35–039 Detroit New Final Drive Standard Performance Forward Carrier Change to Top Performance Passive Lube Management

TSB-35-039-FTL

Creation Date:2023-01-26

Fig. 2, New Standard Performance Forward Passive Lube Management Carrier with Fixed Valve

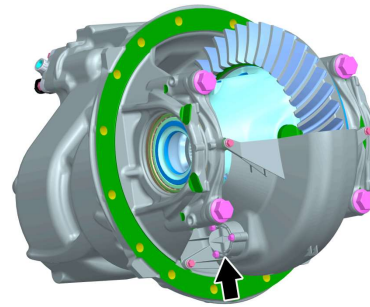
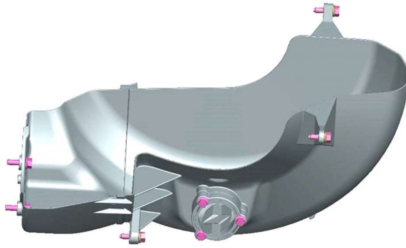
Detroit New Final Drive Standard Performance Axles will have a change to the lube management system. Initially launched without a lubrication management system, the forward rear axle will change to a passive management system. This will be the same passive lube management system as the New Final Drive Top Performance Axle with passive lube management.

The new Standard Performance carriers are backwards compatible, and will fit without modification into the same axle housing. It is okay to have the new carrier with passive lube management system in the forward carrier, and the original carrier in the rear carrier.

The parts will supersede in Excelerator. This change is happening to the forward-rear carrier only. See Fig. [1](#), Fig. [2](#) and Fig. [3](#).

Fig. 4, New Fill Locations for New Final Drive with Passive Lube Management System

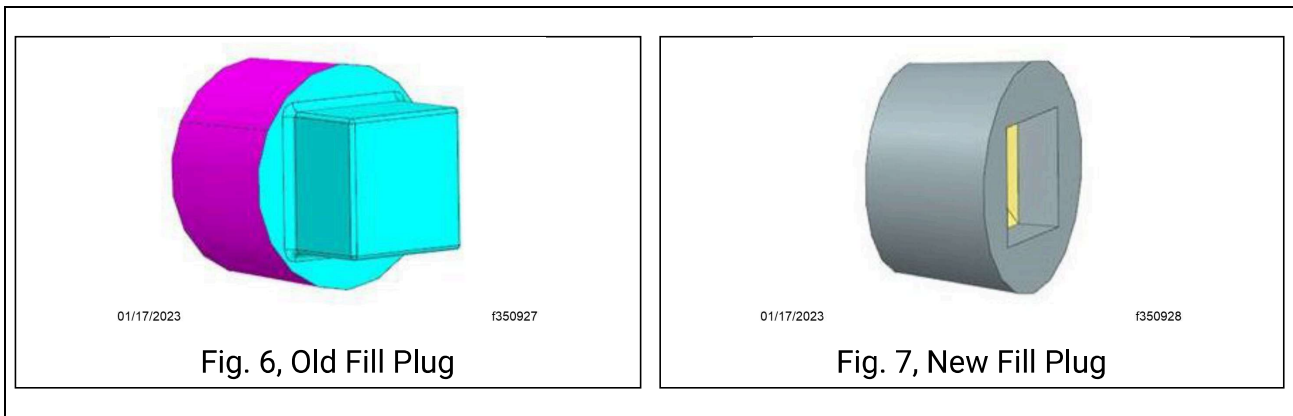
Oil fill locations will change to match the New Final Drive Top Performance locations. See Fig. [4](#). The type of approved oil is DFS93K219.01 only. The rear fill plug part number on the axle housing will change to a new part number (MBA 6809900117), and it will be installed from the inside, similar to the Top Performance carrier. See Fig. [5](#).

1. In order to replace the carrier, clean the housing, and remove the external fill plug from the axle housing.
2. Install the new fill plug (MBA 6809900117) from the inside of the housing. See Fig. 6 and Fig. 7.
